***Planning Department
Transportation Development Services***

**Re: Rio Bravo Brewing Company, LLC
1912 Second St. NW
Traffic Circulation Layout**
Engineer's/Architect's Stamp dated 2/12/15 (H14-D105)

Based upon the information provided in your submittal received 2/18/15, the above referenced plan cannot be approved for Building Permit until the following comments are addressed:

SITE PLAN

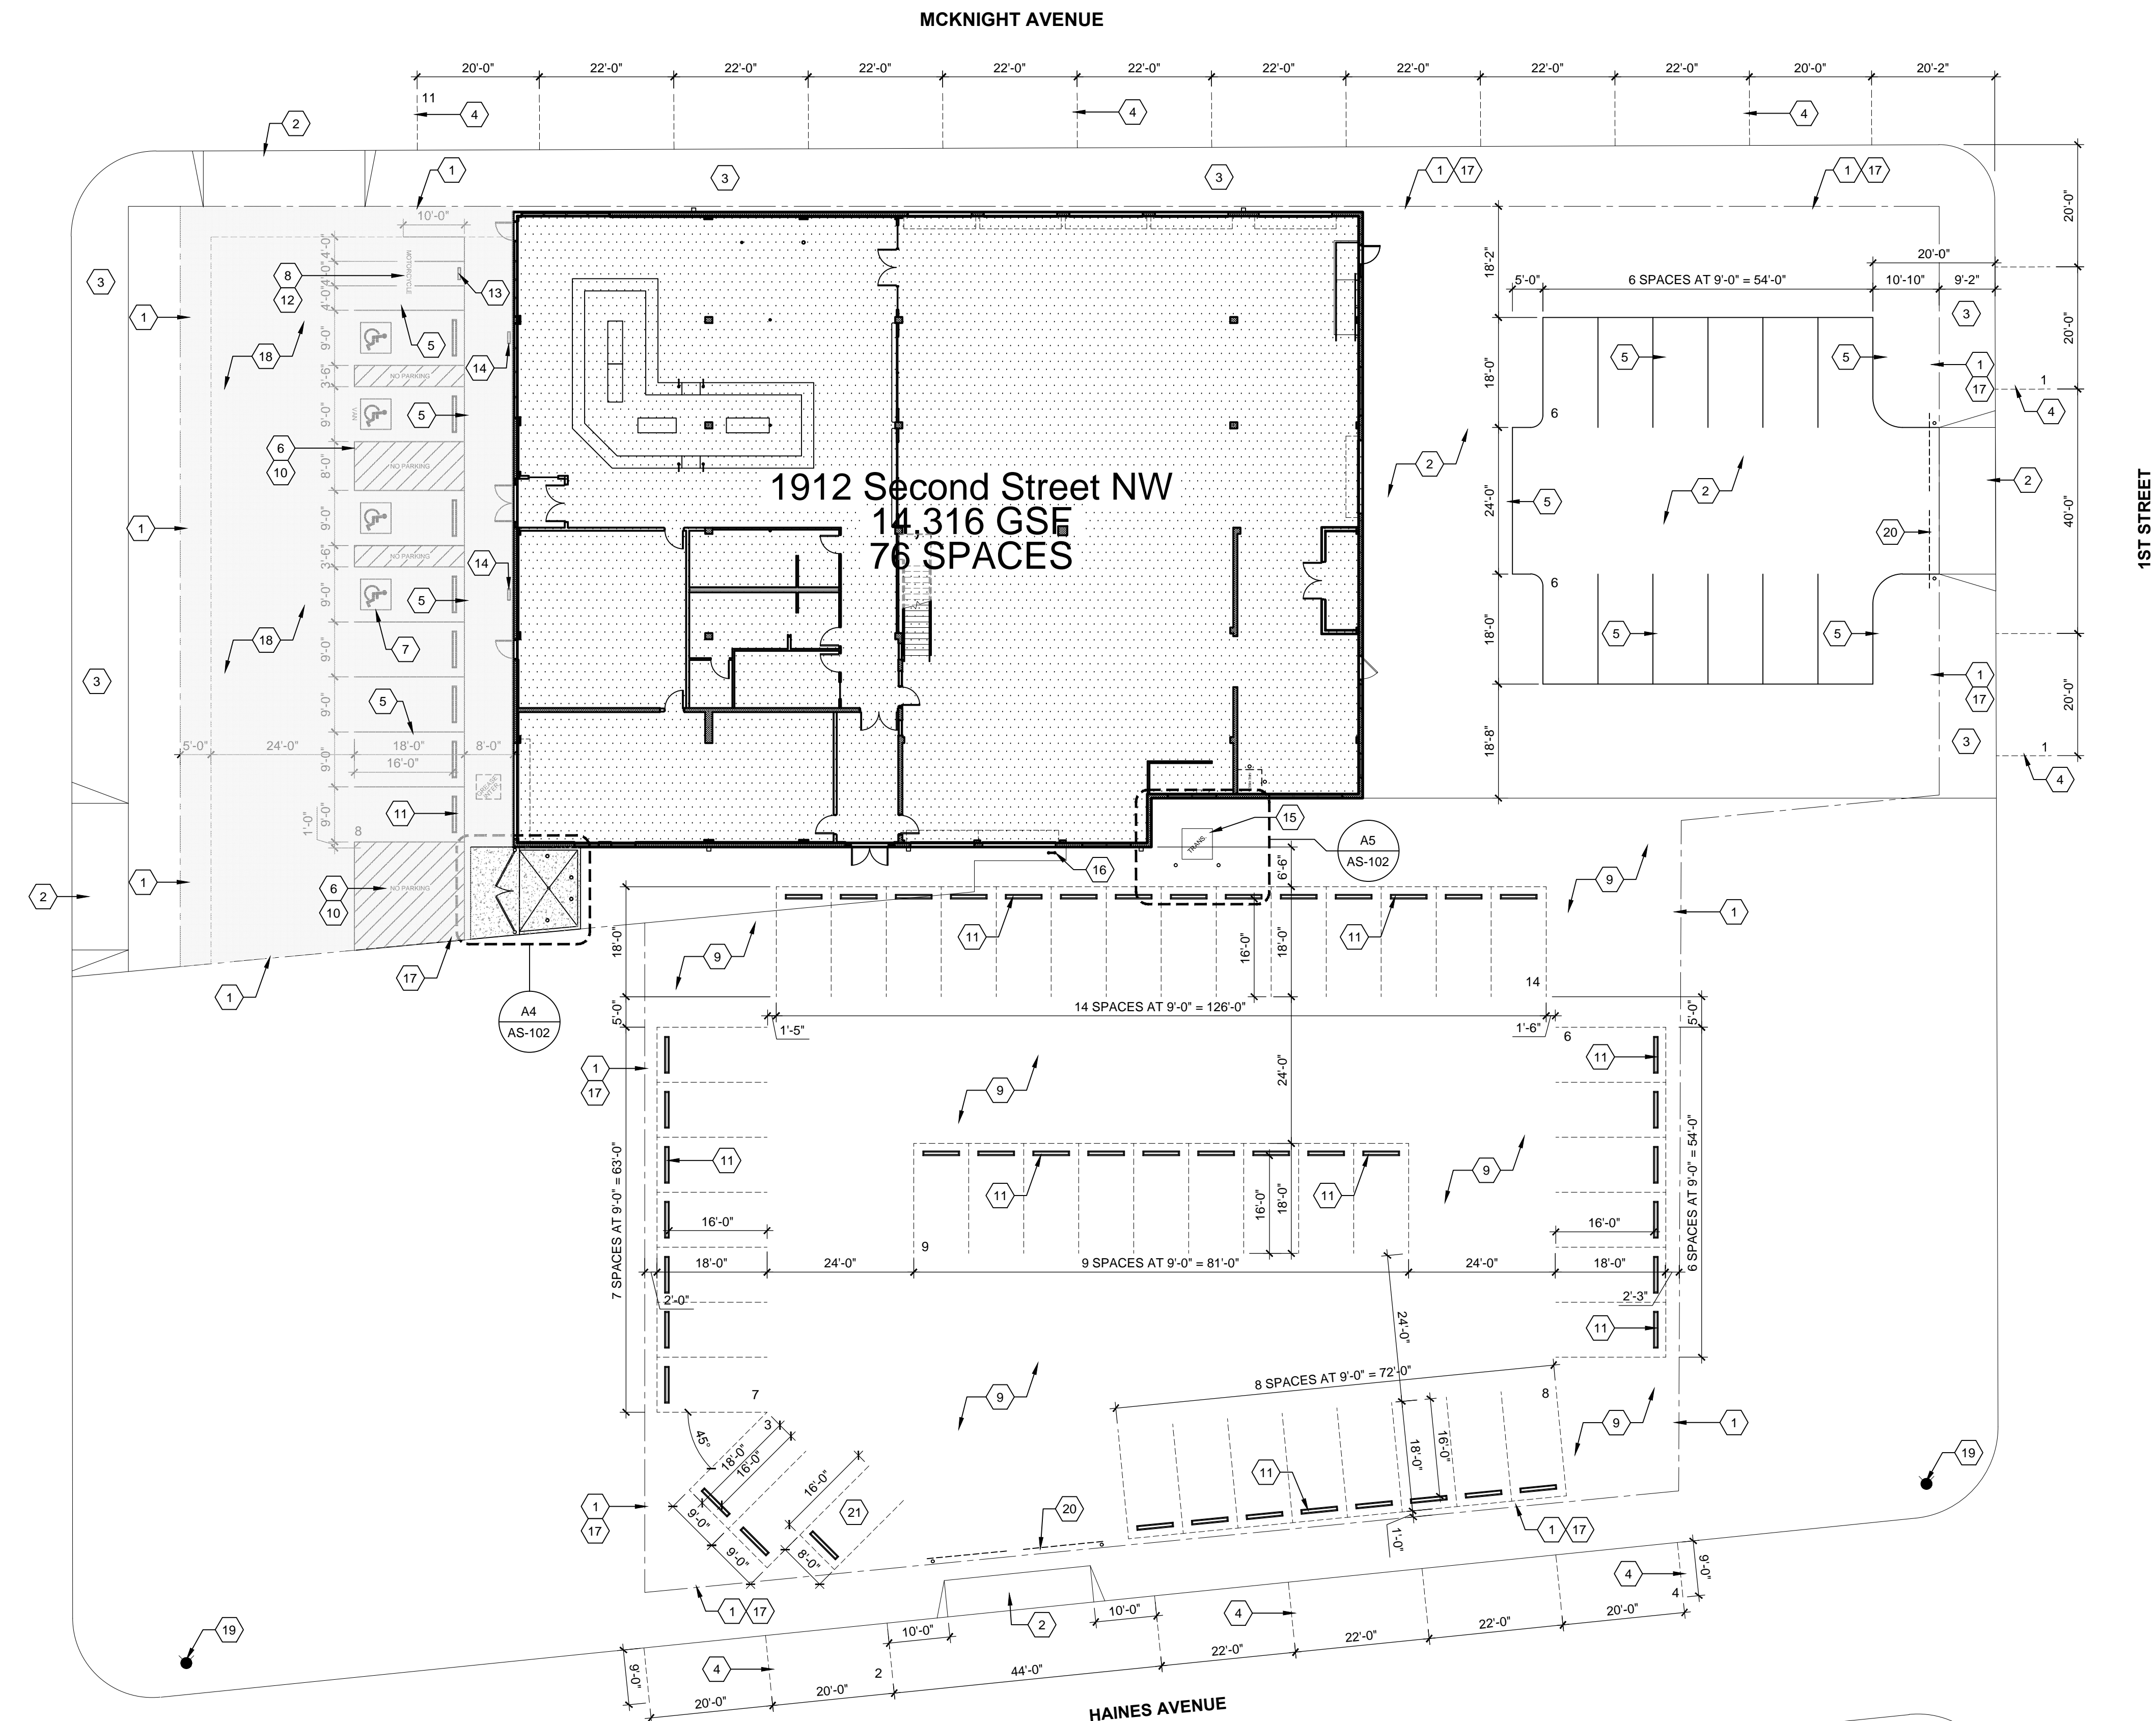
1. Please show a vicinity map showing the location of the development in relation to streets and well known landmarks.
2. Clarify the extents of the current phase of development. Please show existing surrounding buildings, property lines and easements.

3. Please label set-backs for building.
4. On the next submittal, please label drawing as "Traffic Circulation Layout" in lieu of "Site Plan".
5. A scale of 1"=20' is recommended for sites less than 5 acres.

6. Please identify all existing buildings, doors, structures, sidewalks, curbs, drive pads, walls, fences, gates and anything that influences the parking and circulation on the site.

7. Identify all existing access easements and rights of way with dimensions.
8. Identify the right of way width, medians, curb cuts, and street widths on 2nd St., McKnight Ave. Haines Ave. and 1st. St.

9. Clearly show existing sidewalk and handicap ramps within the Public R.O.W.
10. Please provide more detail on grades and slopes in the parking area and/ or the handicap accessible parking areas.

11. The ADA van accessible sign must have the required language per 66-7-352.4C NMSA 1978 **"Violators Are Subject to a Fine and/or Towing."** Please show detail on drawing.

12. The ADA access aisle shall have the words **"NO PARKING"** in capital letters, each of which shall be at least one foot high and at least two inches wide, placed at the rear of the parking space so as to be close to where an adjacent vehicle's rear tire would be placed. (66-1-4.1.B NMSA 1978)

13. Show all drive aisle widths and radii.
14. Please detail all pedestrian walkways, including entrance to building and fencing that directs pedestrian traffic to building entrances.

15. List radii for all curbs shown; for passenger vehicles, the minimum end island radius is 15 feet. Landscape island radius for delivery trucks, fire trucks, etc. is 25 feet or larger

16. A five-foot keyway is required for dead-end parking aisles. Please detail keyway radii on drawing for parking lot south side of building Keynote #2.

17. Per the DPM, a 6 ft. wide ADA accessible pedestrian pathway is required from the public sidewalk to the building entrances. Please clearly show this pathway and provide details.

18. Per the DPM, a 6 ft. wide ADA accessible pedestrian pathway is required from the HC parking stall access aisles to the building entrances. Please provide greater detail of pathway and any elevation changes.

19. All sidewalks along streets should be placed at the property line, if possible.
20. Provide a min 6" or max 8" high concrete barrier curb or other acceptable barrier between landscaping and parking areas and/or drive aisles. Please show detail on drawing.

21. Design delivery vehicle route needs to be shown.
22. Service vehicle and/or refuse vehicle maneuvering must be contained on-site; provide a copy of refuse approval (if applicable). Please provide detail on A4, AS-102 callout.

23. Please specify the City Standard Drawing Number when applicable.
24. Please include a copy of your shared access and/or parking agreements with the adjacent property owner, if applicable.

25. Work within the public right of way requires a work order with DRC approved plans.
26. On-Street parking is not required; please remove any indication of on-street parking from drawing.

27. Unused curb cuts must be replaced with sidewalk and curb & gutter. A build note must be provided referring to the appropriate City Standard.
